Case No. CD-CPC-2021-00239

**416 W. 12th St (Cathedral of the Immaculate Conception) –
Development Plan**

RE: [CD-CPC-2021-00239](#) - CATHEDRAL OF THE IMMACULATE CONCEPTION

3 FACADE TRANSPARENCY STUDY DIAGRAM
 A209 1/8" = 1'-0"

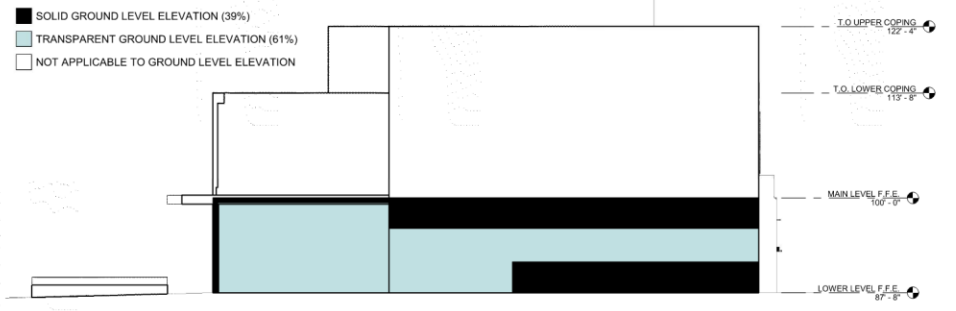
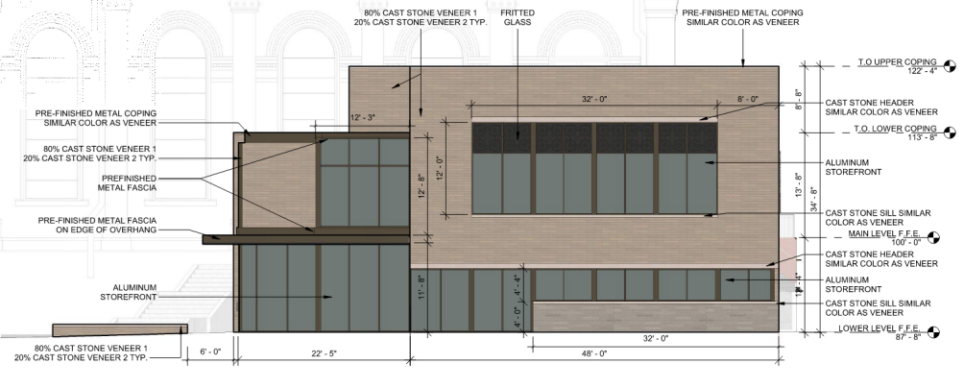
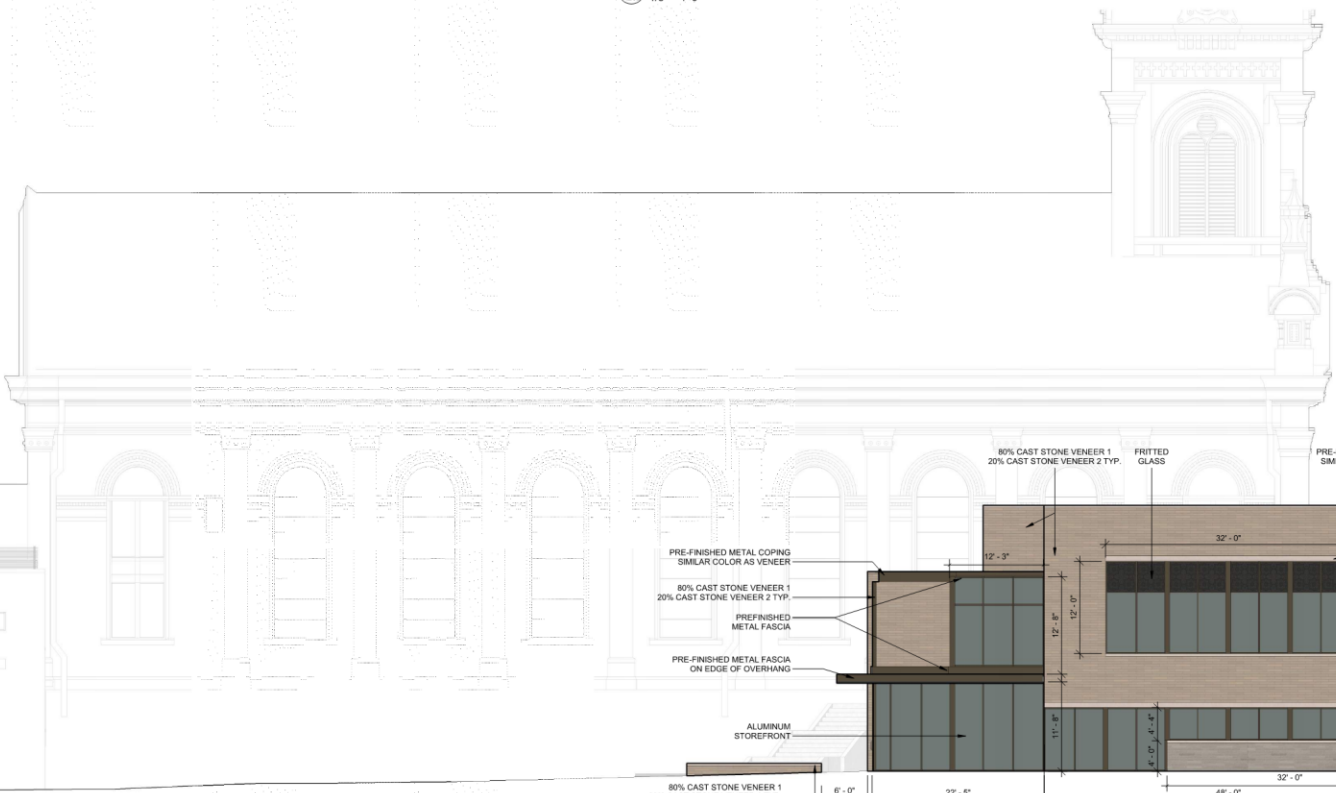
- **The Project should create active facades along the street perimeter.** The primary interior event space is located on the building's second-story and overlooks the southern off-street surface parking lot. Transparent and active facades should be street-facing to promote public visibility and activity. Active uses that face the street promote urban life and provide critical eyes on the street. One simple and budget-friendly way of achieving this goal would be to move the second story of the building down to ground level along Broadway, creating an "L" shape.
